AGREEMENT NO. CE/38/95  
IMPROVEMENT TO KAM TIN ROAD, STAGE 1  
ENVIRONMENTAL IMPACT ASSESSMENT AND  
DRAINAGE IMPACT ASSESSMENT STUDIES

ENVIRONMENTAL IMPACT ASSESSMENT

FINAL REPORT

DOC NO. BBL/96010/007

FIGURE 3.8

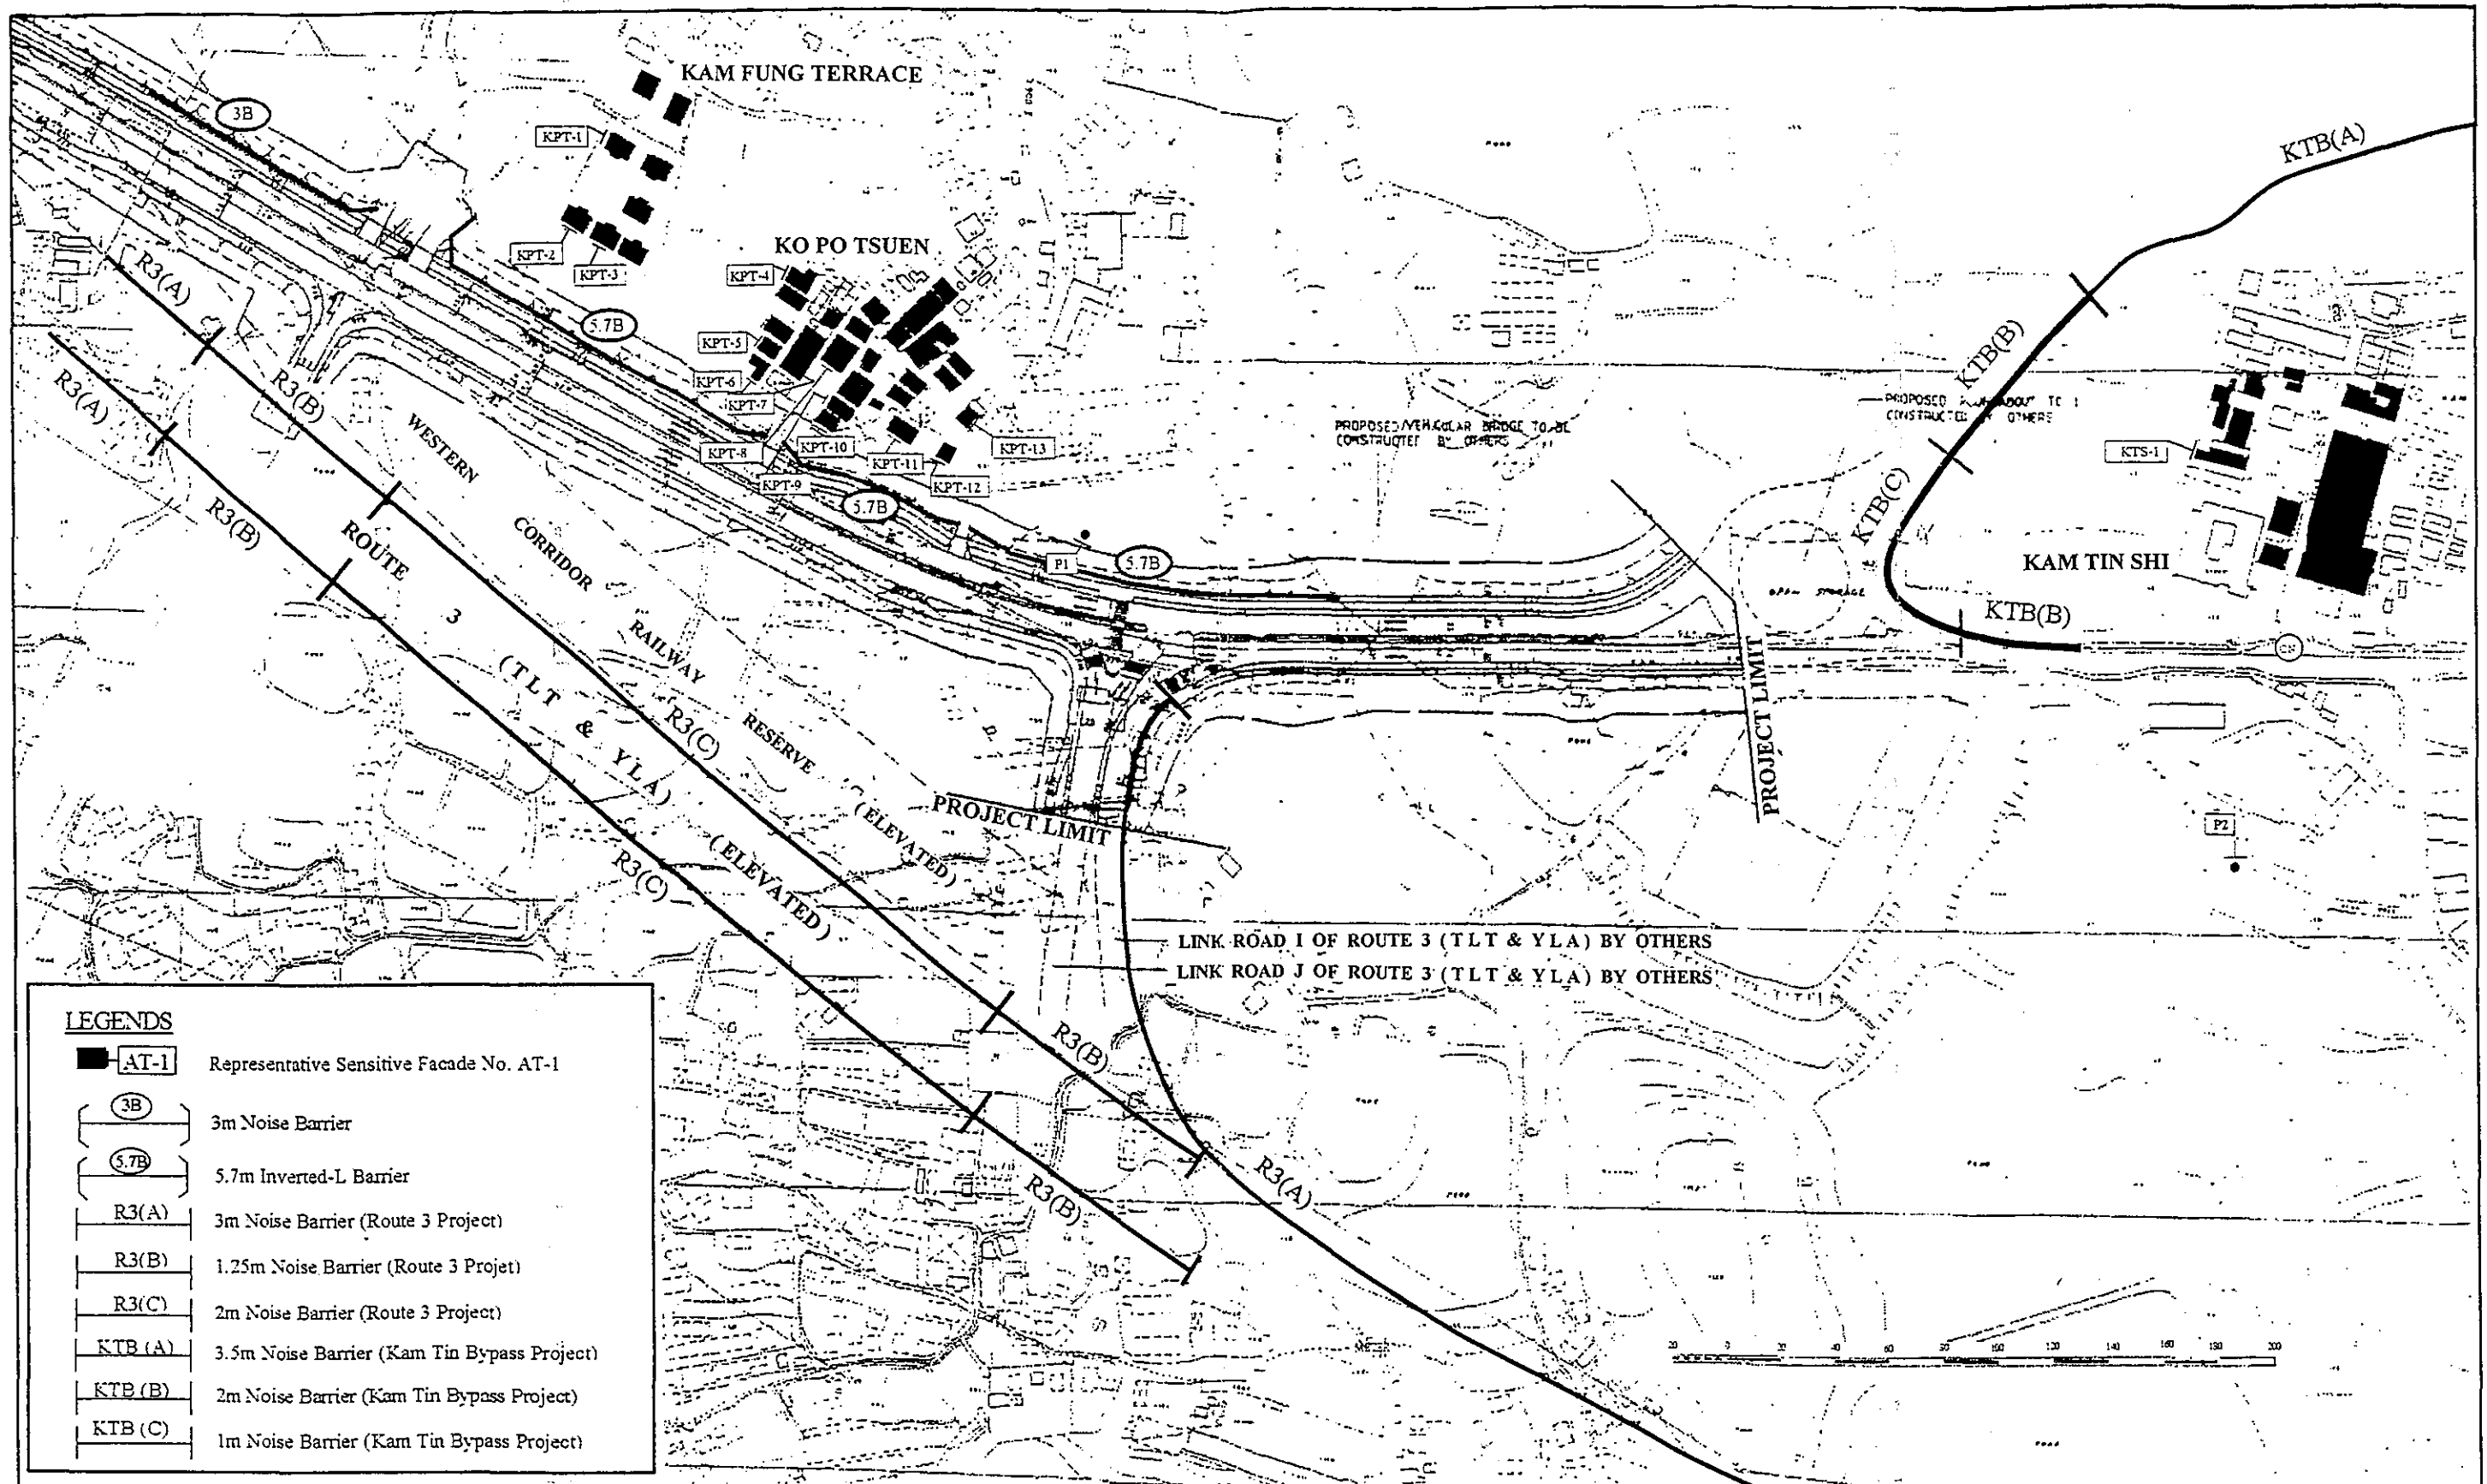
Item No	Dept. letter ref.	Comment	Response
41	EPD Annex (1) to EP 2/N6/23 Pt. II 13 August 1996 (sheet 9 of 9)	<p>(18) Figure 3.8- Noise Mitigation Measures ( Mitigation Scheme 1b) The NSR south of Kam Tin Shi should read "P2" instead of "P1".</p> <p>(19) Page 40, S3.6.2.3 and Page 84, S.7.1 For NSRs KTS-2 and 3 (Kam Tin Mung Yeung Public School and Kam Tin Dragon Kindergarten), please refer to Kam Tin Bypass EIA (S.5.109 and S.5.114) for updated information.</p> <p>(20) Page 53, S.4.7.1 Further to para (iv) of HyD's letter dated 15.7.96, please clarify the area of fish pond loss due to this project on the understanding that the RCP will be relocated elsewhere.</p>	<p>Noted and corrected.</p> <p>Noted.</p> <p>As advised by Highways Department, the loss of wetland area will be minimised as far as possible. The area of fish pond loss will be available in the Design Stage of the Project.</p>

**FIGURE 4.1**

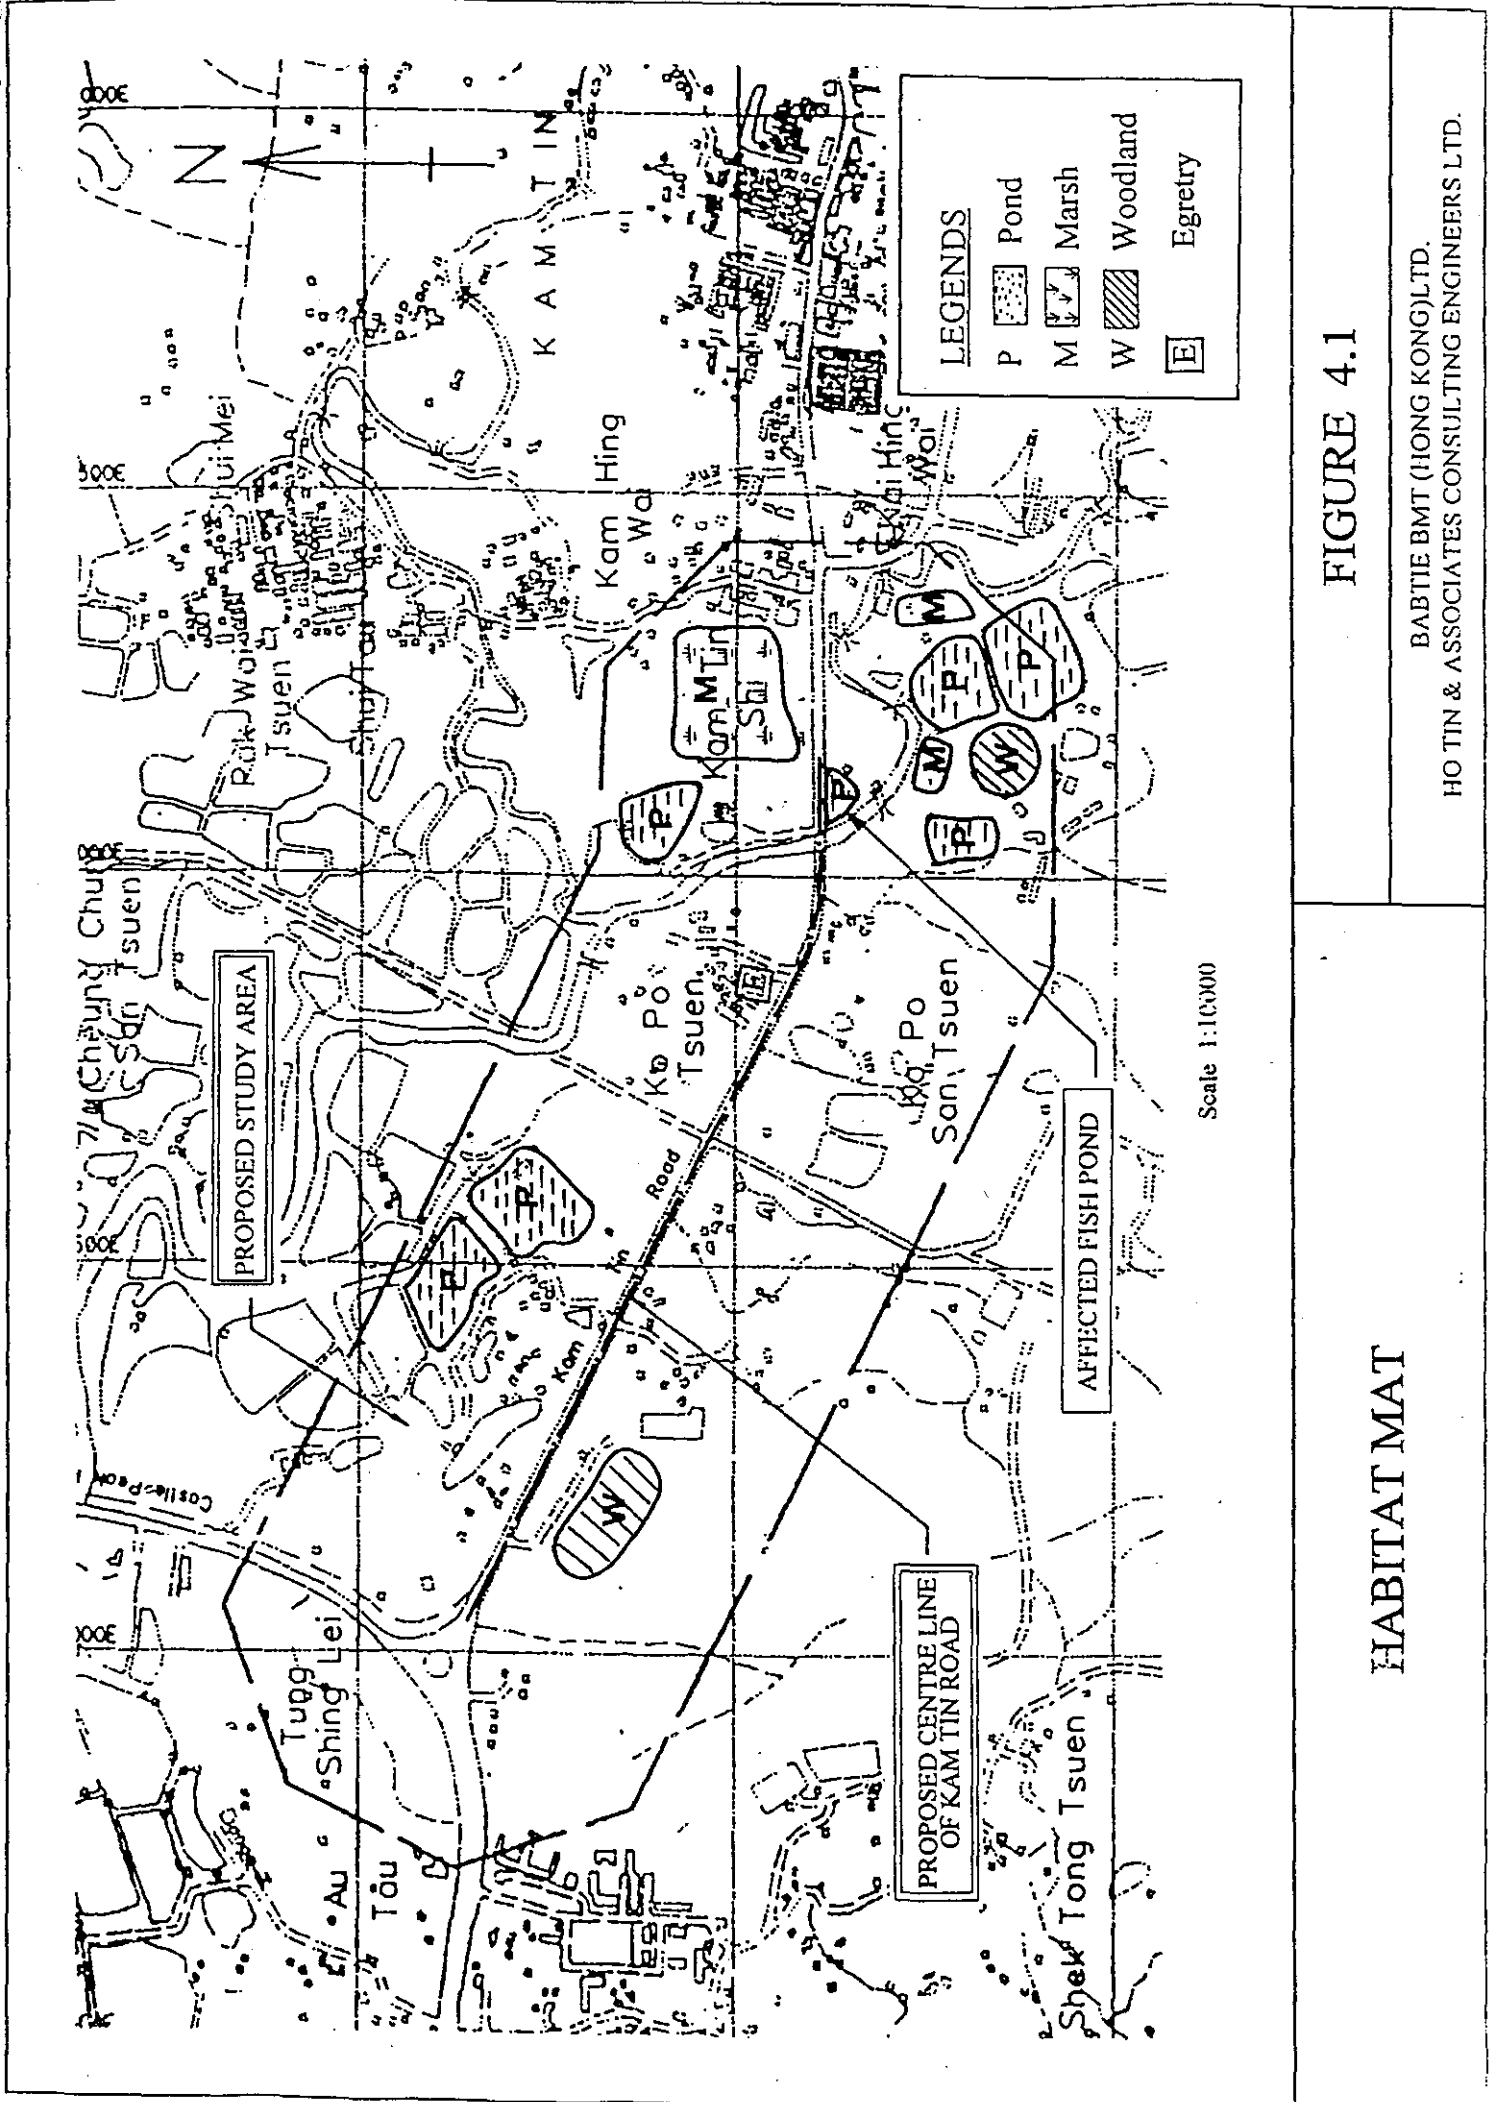
Item No	Dept. letter ref.	Comment	Response
26	KCRC WRMS-000091 1 May 1996	We have no major comment on the EIA Report except a suggestion that the Ko Po Tsuen egretty mentioned on page 71 and 72 be specified on figures, such as figures 4.1 and/or 4.2.	Noted and location of Ko Po Tsuen egretty has been indicated in Figure 4.1.

Item No	Dept. letter ref.	Comment	Response
37	KCRC WRGV-000391 17 July 1996	The location of the Ko Po Tsuen egretty has not been added to Fig 4.1 as stated in the response to comment.	Figure amended.

FIGURE 5.4

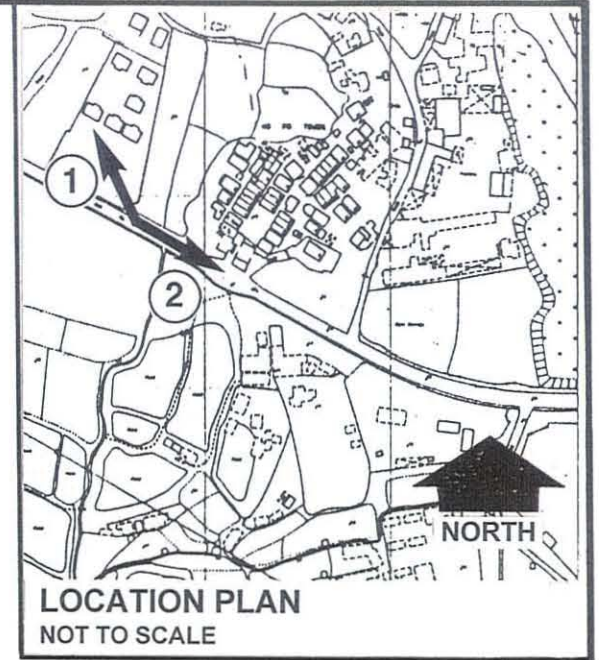
Item No	Dept. letter ref.	Comment	Response
35	HyD/NT ( ) in HNT 54/42 A V 15 July 1996 (sheet 1 of 3)	<p>i) Section 5.8.2 2nd and 3rd lines of the 7th bullet point: "Figures 5.3 and 6.4" should read "Figures 5.4 and 5.5"</p> <p>ii) Section 3.2.2 Please revise the construction period to 30 months to match with the construction programme mentioned in section 2.2.2. Figure 3.2 should also be revised accordingly.</p> <p>It appears that an activity for drainage and utilities should also be required in the second half of the programme.</p> <p>iii) Section 3.6.2.3 &amp; 7.1 Please note that Kam Tin Dragon Kindergarten has been air-conditioned (para. 5.114 of Kam Tin Bypass EIA report refers) while Kam Tin Mung Yeung Public School has been provided with air conditioners under NAMISP, a programme to provide noise abatement measures to schools affected by excessive noise. (para. 5.109 of Kam Tin Bypass EIA report refers).</p> <p>iv) Section 4.7.1 HyD would relocate the concerned RCP elsewhere and avoid encroaching into the fish pond as far as possible during the detailed design stage. Therefore, it seems that the area of the fish pond loss could be reduced to minimal.</p>	<p>Noted and amended.</p> <p>Noted and amended.</p> <p>Noted and amended.</p> <p>Noted and amended.</p> <p>Noted and amended.</p>
